**Re: Defect Information Report – Supplemental Report No. 4
09V-344, FL-556, C2 Door Glass Bonding**

Subject: RECALL 09V-344 – AG2 Entrance Door Glass Bonding/Retaining Brackets

RECALL #09V-344

SUBJECT: AG2 ENTRANCE DOOR GLASS BONDING / RETAINING BRACKETS

Figure 1

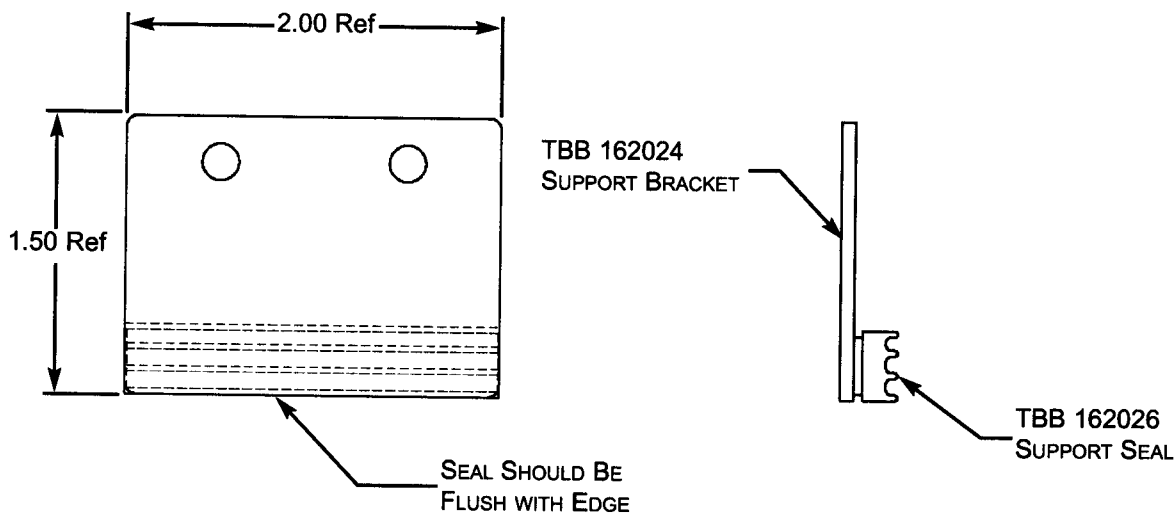
1. Remove the adhesive backing from the Support Seal, TBB 162026 and assemble to the Support Bracket, TBB 162024 as shown in **Figure 1**. Repeat this step to create 16 Support Assemblies for the entrance door glass.

Figure 2

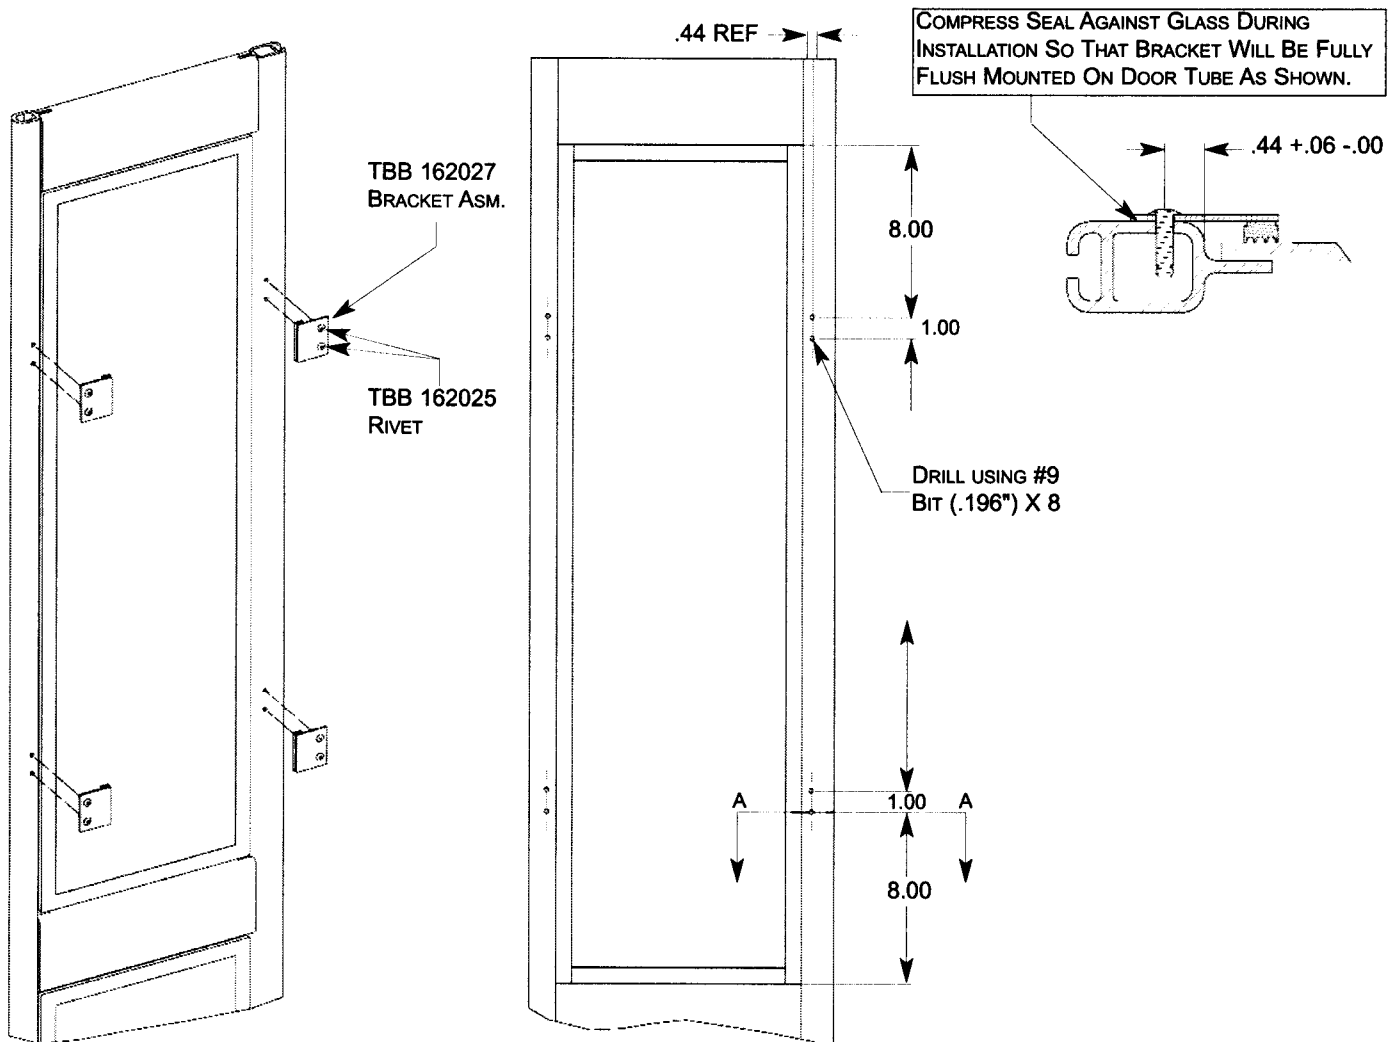
2. Reference **Figure 2** for Support Assembly mounting locations. The locations shown are the same for each of the four (4) AG2 door glass positions. Drill through one (1) wall of the AG2 entrance door frame using a #9 (0.196") bit for each mounting hole.
